**RTCA Special Committee 186, Working Group 5**

**ADS-B UAT MOPS**

**Meeting #11**

**Proposal for Sectorized Ground Antenna**

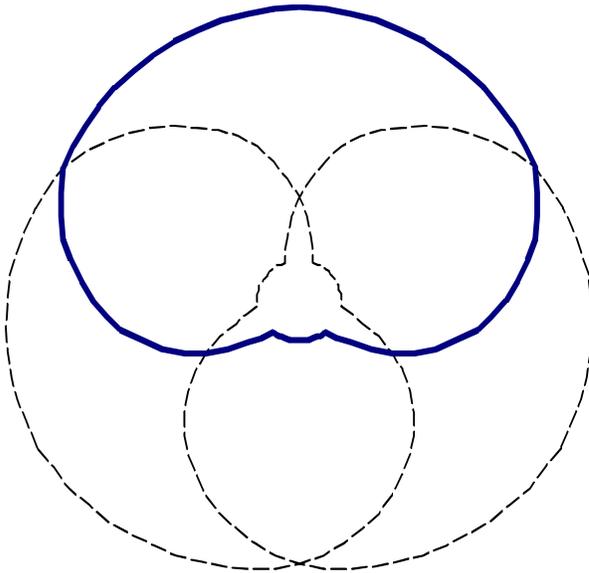
Can we use DME pattern vertically and sample comm antenna horizontally?

What do we currently use for vertical pattern? Is there a null above? Is there ground rejection?

Go through DME power budget. What was that about the notch filter?

How do we interpret dBd?
